II. AMENDMENTS TO THE DRAWINGS

Application No. 10/647,030

Fig. 6

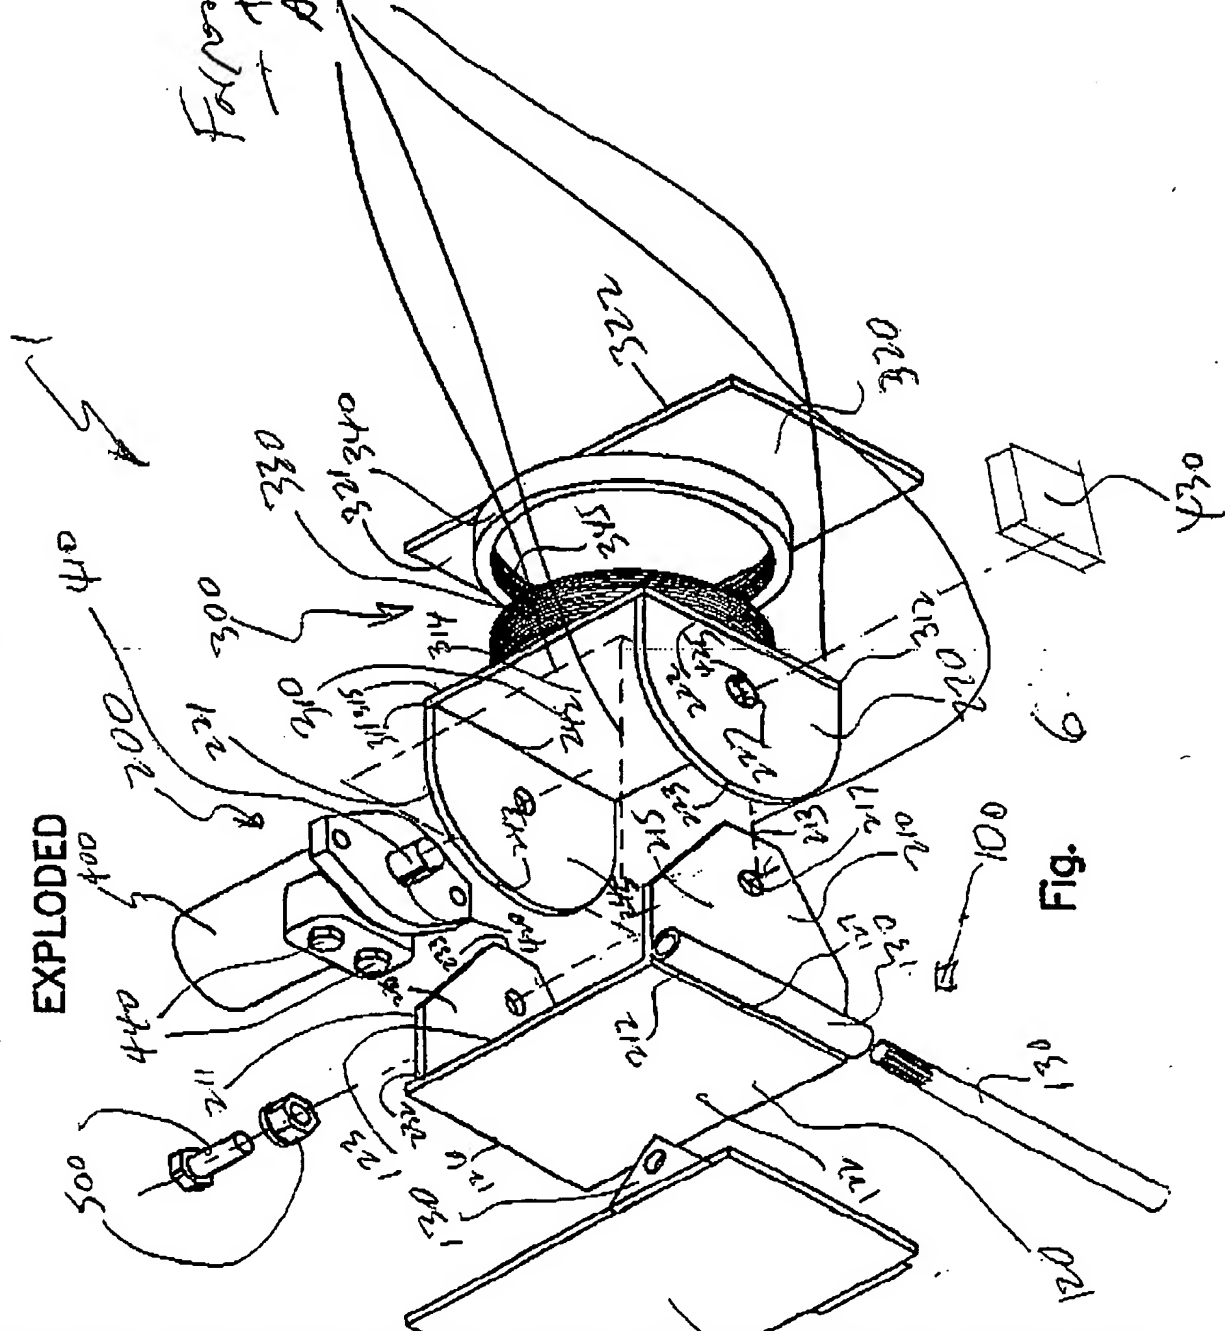
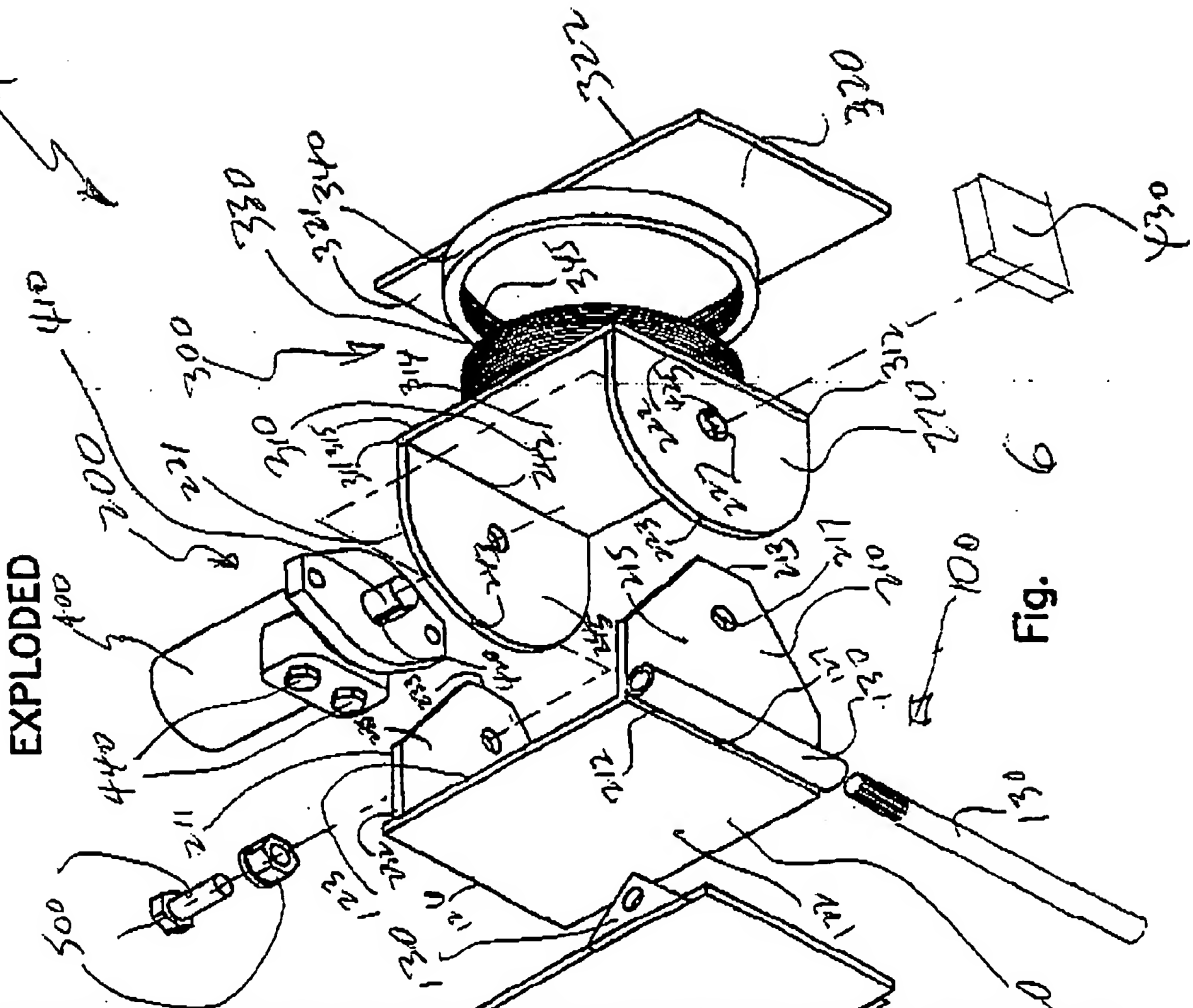
The Examiner states at page 3, paragraph 2 that the drawings of 10/4/04 are not approved because it is nuclear what changes have been made and that they do not overcome the objection set forth at page 3, paragraph 3 re: the substituted "figure shows modified forms of the drive means because it shows both the gear means 430, and the key/notch 420/425." and that these structures are mutually exclusive drive means.

For response 3/3/05
the dashed line
shows the displaced
from the
Immediately
preceding fig. 6.

The identical drawings for Fig. 6, as submitted on 10/4/04, are again submitted with direction respectfully provided by line and note. The Examiner will see in the "Replacement Sheet 10/4/04" the dashed line indicating that the motor is affixed between the two sets of plates with the shaft engaging only apertures (217) and (227).

Regarding the matter of notch v. gear, your applicant respectfully submits that matter of the motor (400) being immovably affixed to one plate (215) and either notch/key or gear related to a second plate (220) will be obvious to one of ordinary skill. Your applicant is agreeable to submitting an additional drawing as Fig. 6A showing the gear removed but respectfully submits that such will require the additional drafting time in amendment of the specification. Your applicant submits that those of ordinary skill will appreciate the drawings as illustrating options.

Your applicant respectfully requests the Examiner to accept Fig. 6 as amended and as submitted in the prior paper and to withdraw the objection and allow the application to be prosecuted on the merits. Your applicant observes that the Examiner states at page 4 that "If changes are not accepted by the examiner, the applicant will be notified and informed of any required corrective action in the next Office action. The objection to the drawings will not be held in abeyance." Your applicant is uncertain of the meaning of these statements and requests the Examiner to consider the requests of the applicant and to advise if additional changes are required.
